**FIELD SAFETY NOTICE – FSCA****Instructions for users on how to handle the affected product.**

SIGNUS implant:

Item number	Batch	Date of manufacture	Item description
PSL052043	LOT 857931-BC	01.11.2024	POSEIDON ST Endplate 20x43mm 5°

## Instructions for correcting the connecting screw

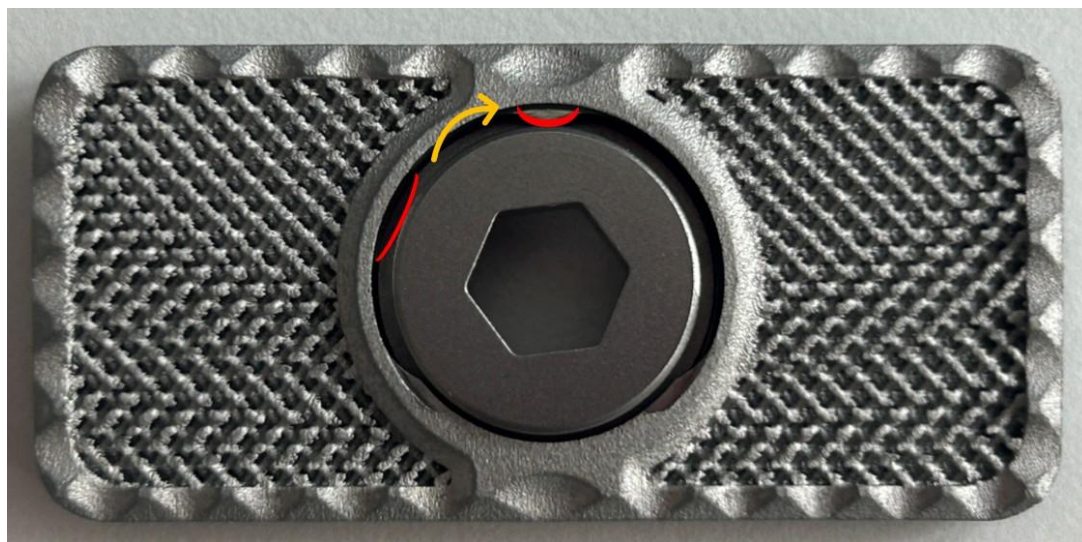
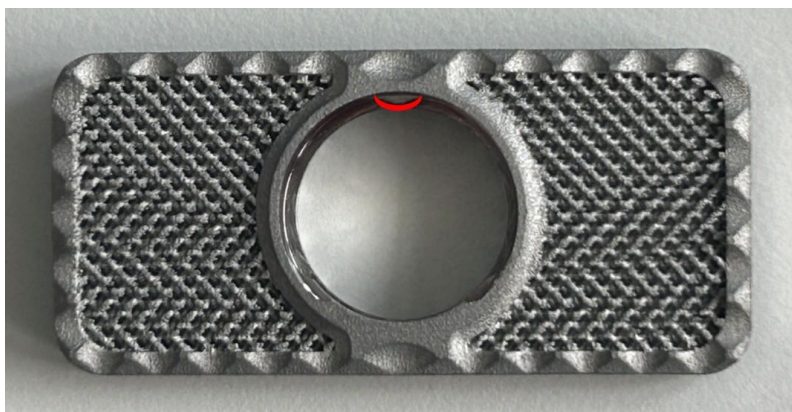
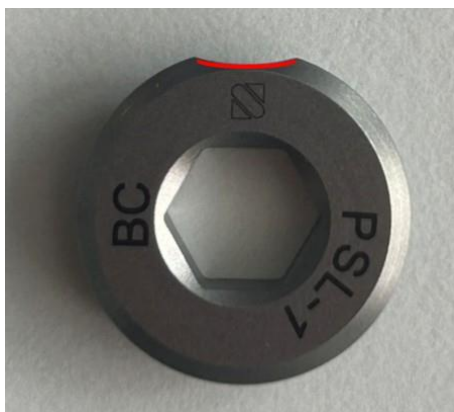
The above-mentioned implant batch has an incorrectly assembled connecting screw.

Due to the incorrectly assembled connecting screw, the end plate cannot be mounted on the base body if the screw is not corrected during preparation. When the VBR is inserted, the plate will detach from the base body.

BEFORE correction	AFTER correction
Endplate teeth at top and connecting screw labeling <b>at bottom/not visible</b>	Endplate teeth at top and connecting screw labeling <b>at top/visible</b>

Before using the end plate, the screw must be removed, turned around, and reinserted correctly (with the screw label facing the "end plate teeth at the top").

Turn the connecting screw until the notch on the screw is aligned with the bulge on the plate. The connecting screw can be removed by tilting it sideways.

Turn the connecting screw so that the labeling on the screw and the teeth on the endplate are at the top.

The connecting screw must be inserted into the endplate with the labeling facing upwards.

The connecting screw must be aligned so that the notch on the screw is in line with the bulge on the plate.

The screw is then inserted at an angle into the endplate and turned.
